Cambridge Halls, Manchester

Transport Statement Addendum

Reference: CAM-ARP-XX-XX-RP-OT-0003

P01 | 18 August 2025

Figure 3: Cross Section View of New Proposed Cycle and Walking/Wheeling Routes Through Site (Looking North)

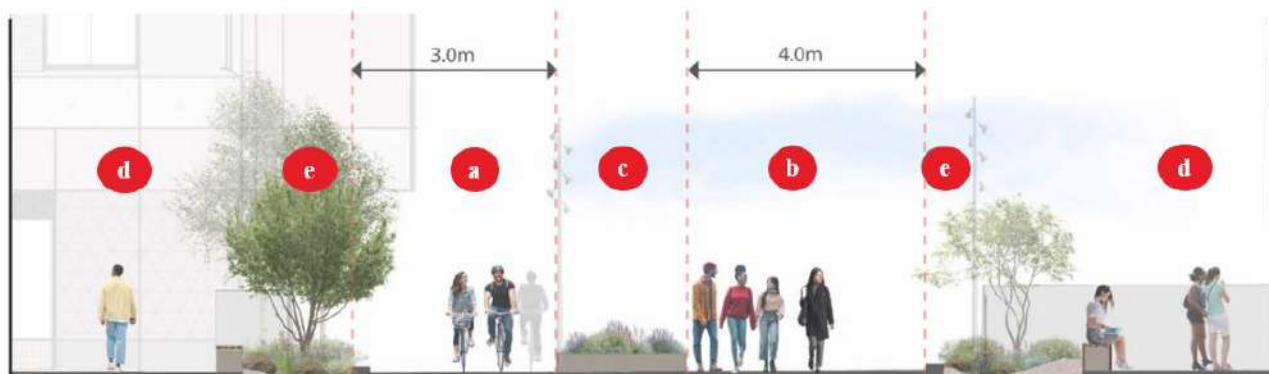
Figure 3 shows the proposed cross-section of the new landscaped route highlighted the following features:

- a) 3.5m wide cycle path (LTN 1/20 compliant);
- b) 4m wide footpath;
- c) landscaped segregation between cycle and walking routes;
- d) student access only area; and
- e) planting and secure fence line.

Figure 6: Proposed Changes to Higher Chatham Street and Lower Chatham Street.7

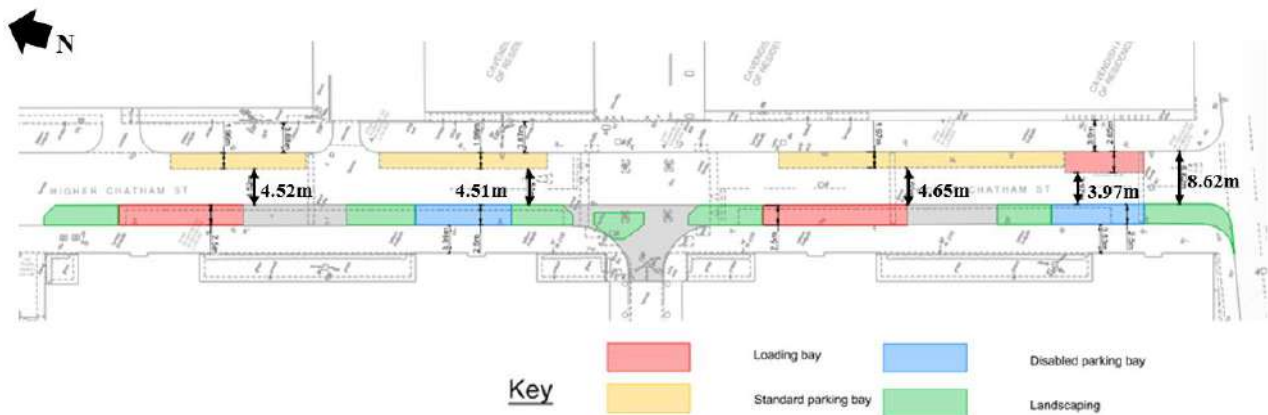
The proposed layout for Higher Chatham Street and Lower Chatham Street has been revised following the consultation response. The revised layout proposals is annotated as Figure 6.

The changes incorporated to the latest proposed layout include:

- Retaining the existing kerb line for the nearside edge of disabled parking and loading bays.
- Landscaped buildouts extend into the carriageway as far as the proposed disabled parking and loading bays.
- Tapered splays have been introduced to the proposed disabled parking and loading bays to facilitate smoother vehicle manoeuvring.
- Low level planting will be introduced to the landscaped build out and trees in an arrangement that does not obscure driver visibility.

The narrowest effective passing width of 3.97m is between the disabled parking and loading bays on Higher Chatham Street and occurs in the event of both the disabled parking and loading bays are occupied. Observations on site have noted that the existing loading bay shown closest to the Boundary Street West/Higher Chatham Street junction is not continuously occupied.

With the exception of the aforementioned scenario, passing widths range between 4.51m and 4.65m between bays/buildouts which is greater than the 4.1m threshold as suggested in Section 7.1 of Manual for Streets guidance that allows two-cars to pass or a lorry passing a cyclist. The proposed marginal narrowing of the carriageway is intended to encourage slower speeds whilst also providing an enhanced landscaped street to encourage pedestrian, wheeling and cycling movements.

Drawing Title
Lower Chatham Street Servicing
Swept Path Analysis
4.6t Light Van

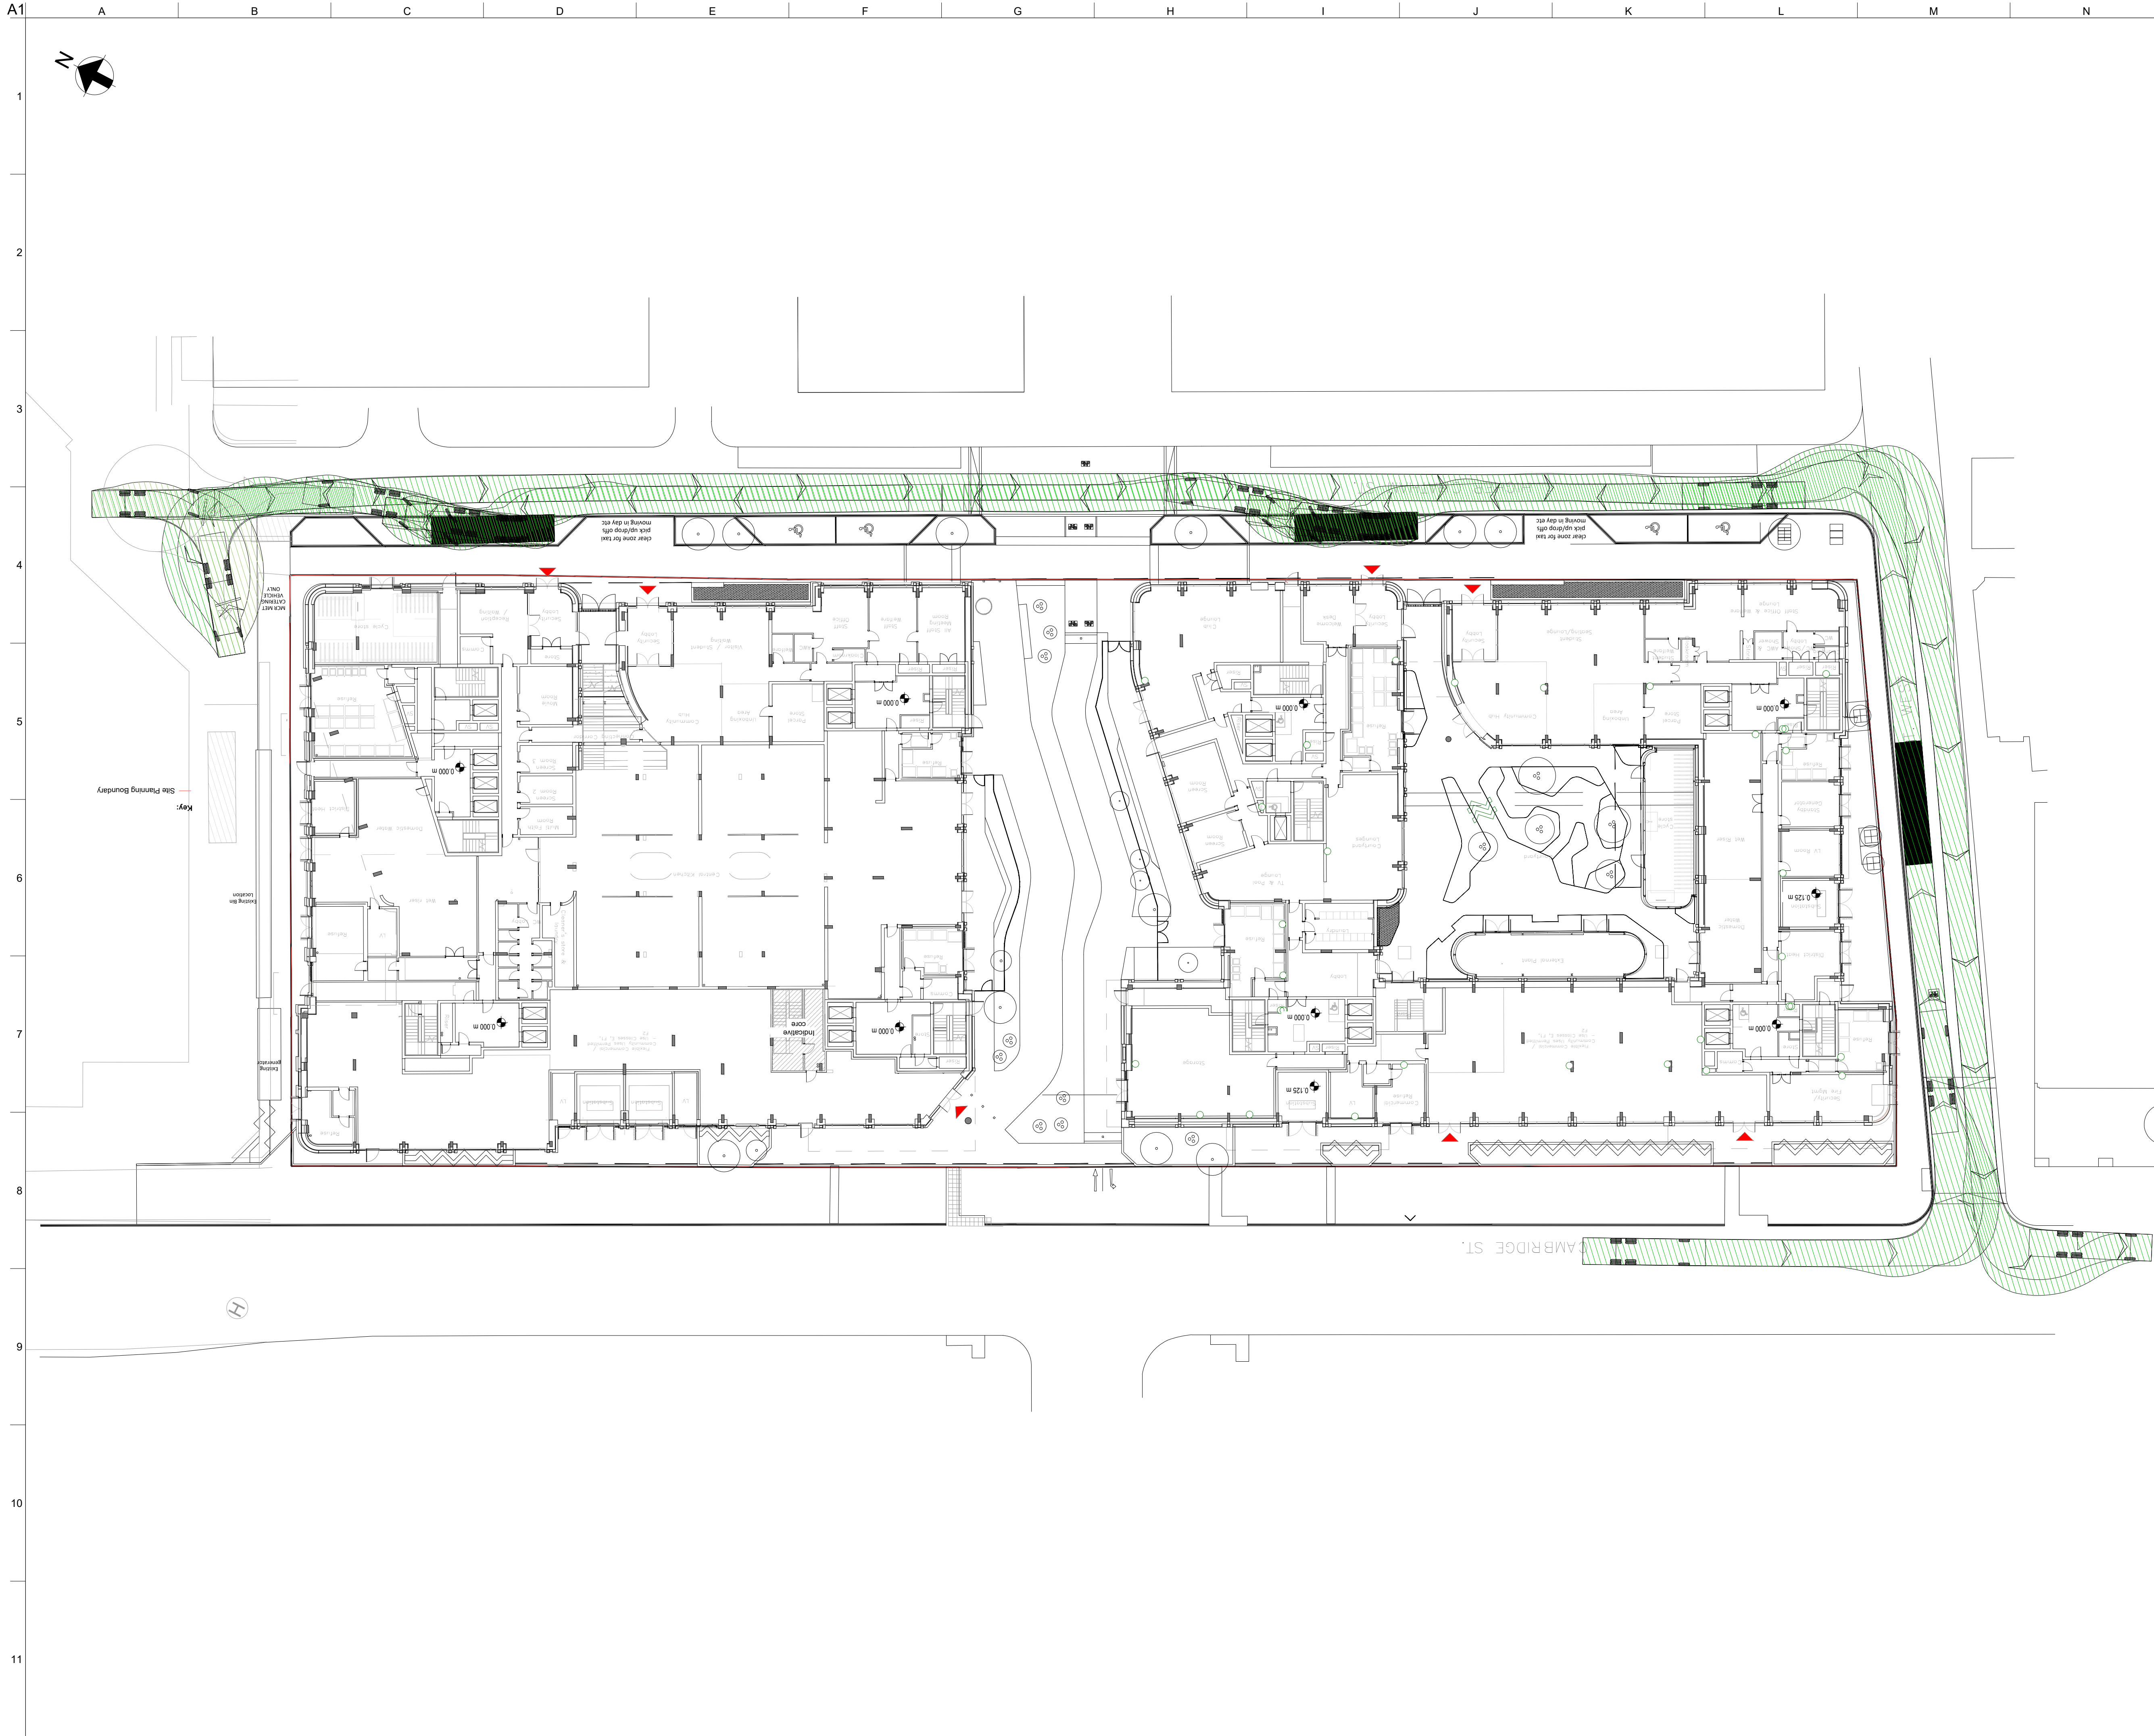
The vehicle swept path analysis presented in the submitted Transport Statement has been updated to reflect the latest arrangements. Drawing 303452-00-SK-003 and 303452-00-SK-004, contained in Appendix B, shows a light goods van and refuse vehicle can satisfactorily serve the development.
